03.1-04

TECHNICAL BULLETIN

Poor Idle Quality –
Normally Aspirated AJ16 Engine –
Valve Timing Modification

MODEL 1995 MY
4.0L NA
VIN
See engine no. below

ILLUSTRATION 1

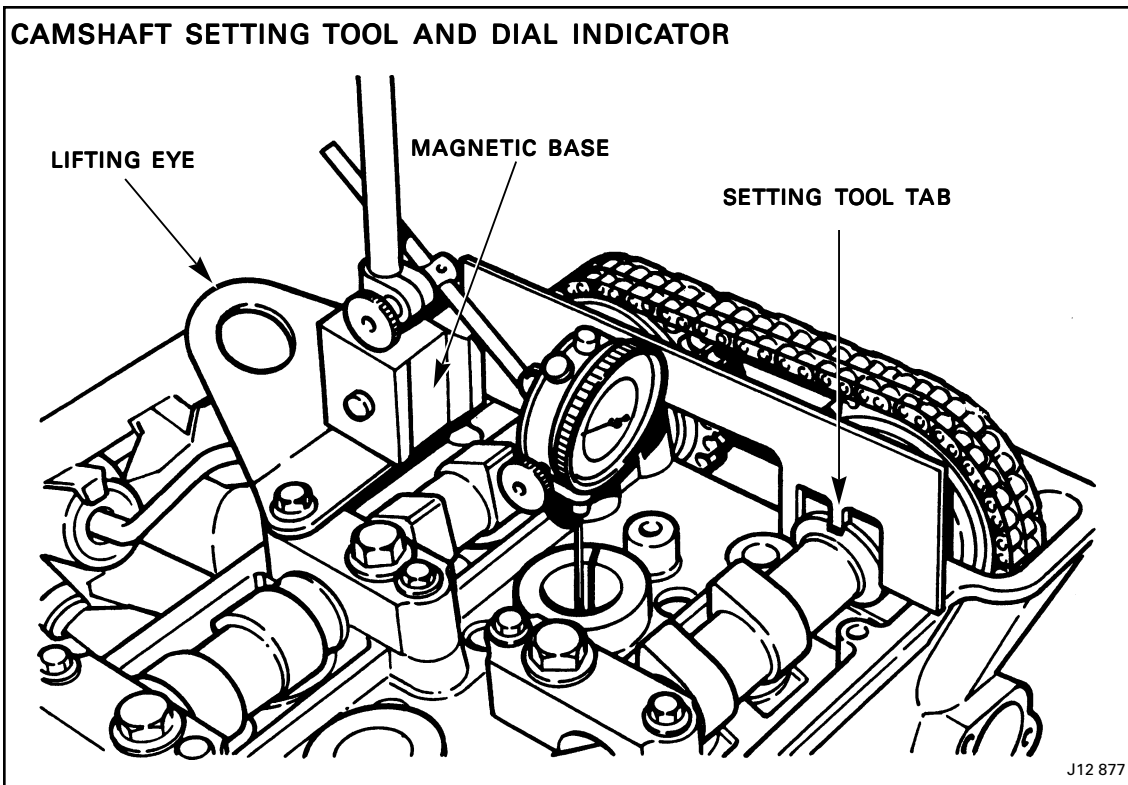
5. Turn the crankshaft until the No. 1 cylinder is at Top Dead Center (TDC) on the compression stroke, i.e. with the cam lobes on the No. 1 cylinder pointing upwards as in Illustration 1. This position can be checked by temporarily inserting the camshaft setting tool 18G-1433/A into the slot on each camshaft.

7. On all engines, attach an engine lifting eye to the intake camshaft cap as shown in Illustration 1.
8. Position the magnetic base of a dial indicator gauge on the lifting eye.
9. Install the dial indicator gauge with an extension pointing downward, into the spark plug bore, contacting the top of the piston.
10. Bend back the locking tabs that lock the bolts holding the camshaft sprocket vernier couplings to the camshafts. Loosen the bolts slightly, but do not remove them.
11. Remove the camshaft setting tool. Rotate the crankshaft back and forth slightly across the TDC position to determine the true TDC point for the no. 1 piston and then zero the gauge.

ILLUSTRATION 3

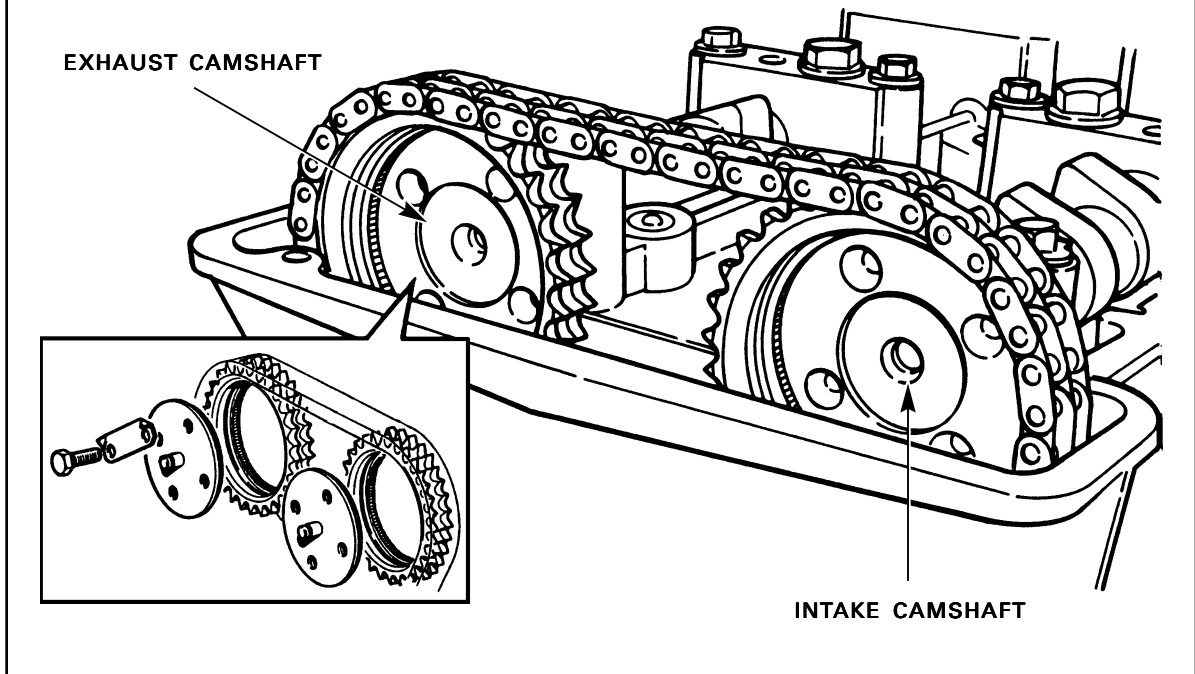
21. Remove the retaining bolts and the camshaft sprocket vernier coupling, Illustration 3, from the intake camshaft, but do not detach the sprocket from the camshaft flange. The camshaft is free to rotate inside the sprocket with the coupling removed.
22. Position the camshaft setting tool 18G-1433/A across the camshafts with the positioning tab on the intake camshaft.
23. Turn the intake camshaft until the tab on the setting tool engages the slot in the camshaft.
24. With the camshaft in this position, reinstall the sprocket vernier coupling to the intake camshaft. This step will require several attempts to find the exact alignment of the vernier splines and the bolt holes.
25. Install the locking tabs and the coupling bolts. Lightly tighten the bolts.

19. Install the locking tabs and the coupling bolts. Lightly tighten the bolts.
20. Remove the setting tool and turn the crankshaft in a clockwise direction (viewed from the front of the engine) until the pointer is one and a half teeth after the arrowed (TDC) tooth edge on the timing ring, position B, Illustration 2.

ILLUSTRATION 4

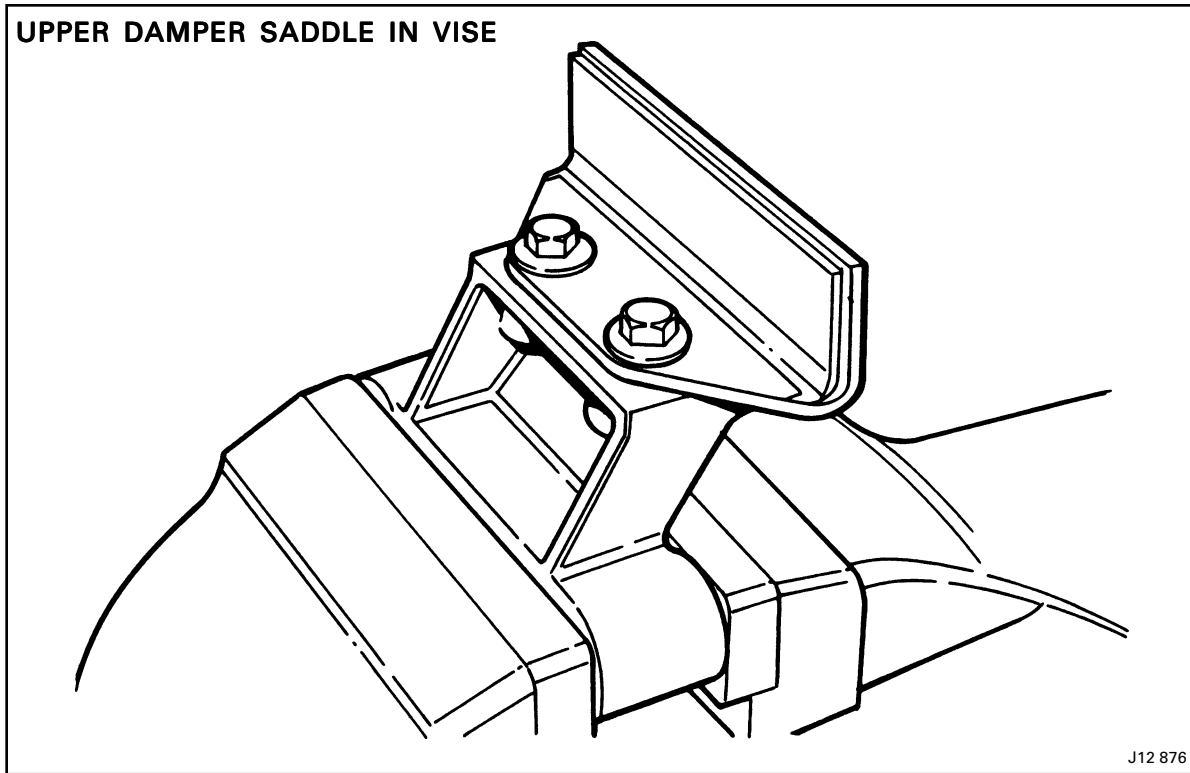
28. Remove the setting tool, the dial indicator gauge, and the lifting eye. Torque camshaft bearing cap bolt to 12.5 - 16.9 lb ft (17 - 23 Nm).
29. On engines with numbers below 9L103934 (XJS Range) or 9J103935 (Sedan Range) only, remove the damper saddle retaining bolts, Illustration 4. Thoroughly degrease the bolts and the saddle. Apply Loctite 545, part number 54531 to the bolt threads and torque to 15.8 - 21 lb ft (21.5 - 28.5 Nm). Install the damper saddle using new cylinder head bolts and torque to 43.5 - 44.9 lb ft (59 - 61 Nm) plus 90 degrees as described in section 2.1 of the AJ16 Engine Service Manual.

NOTE: Engines starting with 9L103934 (XJS Range) or 9J103935 (Sedan Range) do not require modification since the damper saddles are equipped with self locking bolts.

ILLUSTRATION 5

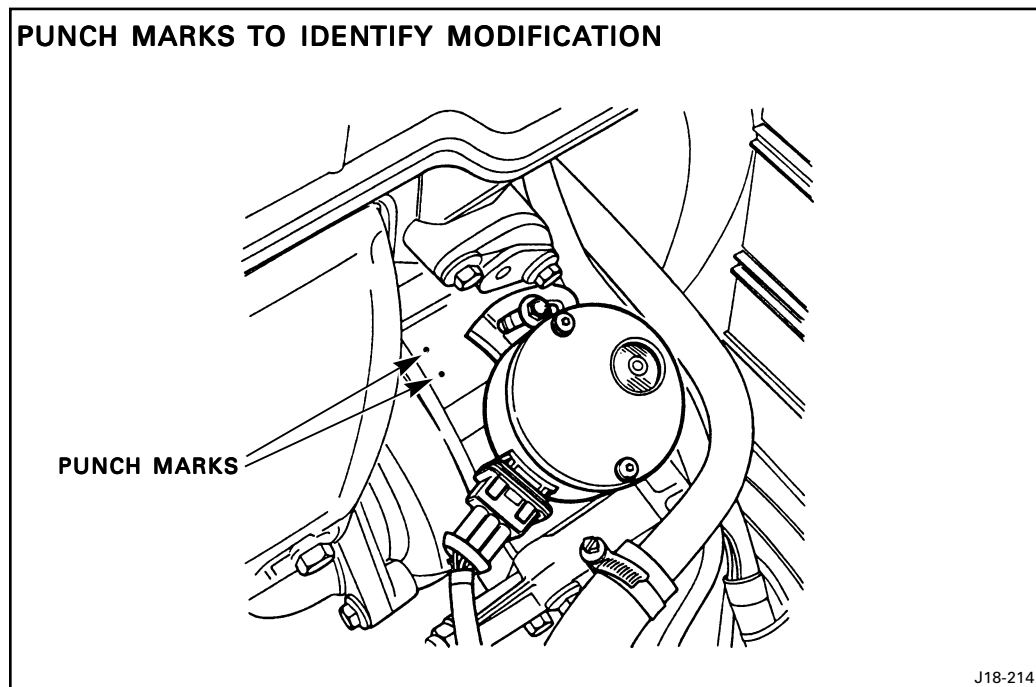
In case of a customer complaint of poor idle quality on a vehicle equipped with the 110 camshafts only, first check for punch marks on the timing cover near the camshaft position sensor, Illustration 5, to determine if the timing modification has already been performed. If not, reset the camshaft timing and spark plug gap as described below.

33. Place two punch marks approximately 1/4 inch apart on the timing cover parallel to the lip, Illustration 5, to indicate that the modification was done.
34. Connect the battery negative cable and reset the clock.
